Docket Item #7 A-E & #8

Master Plan Amendment #2008-0004  
Rezoning # 2008-0001  
Coordinated Development District # 2008-0002  
Development Special Use Permit # 2008-0013  
TMP Special Use Permit # 2008-0060  
Text Amendment # 2008-0007 (Docket Item #8)

Planning Commission  
October 7, 2008

**DSUP #2008-0013**

## Attachment #2 – Open Space Expansion

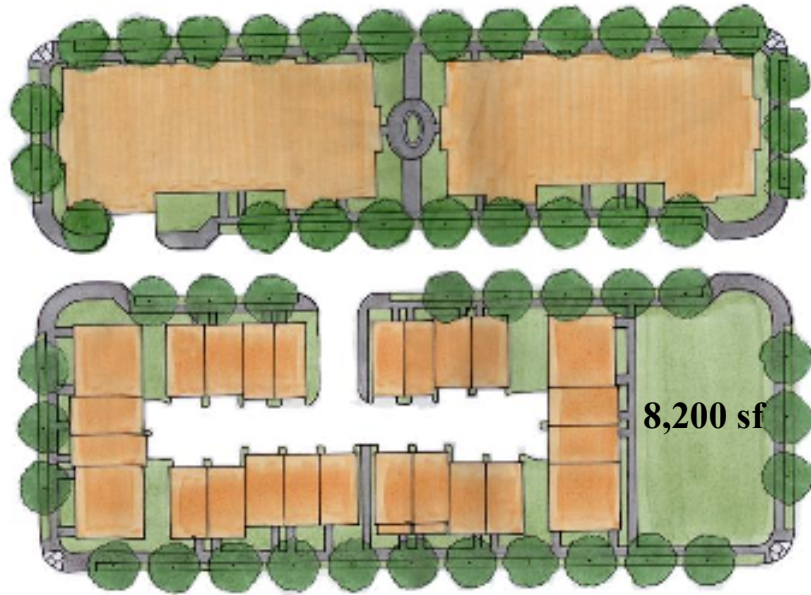
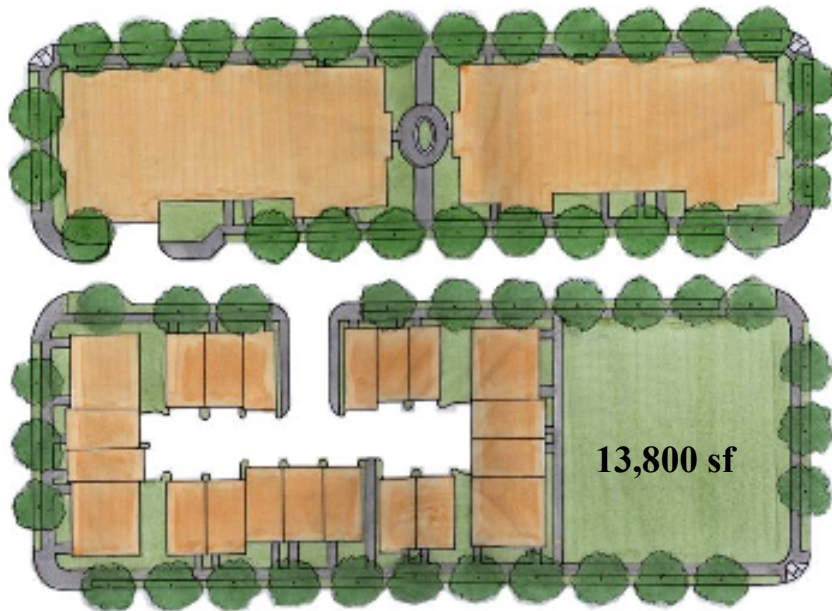
9. The applicant shall revise the site plan to eliminate 4 units in the southwestern block to provide a larger open space area at the corner of Montgomery Street and N. Alfred Street as generally depicted in *Attachment #2*. The park shall be subject to the following, to the satisfaction of the Directors of P&Z and RP&CA:

Staff Recommendation
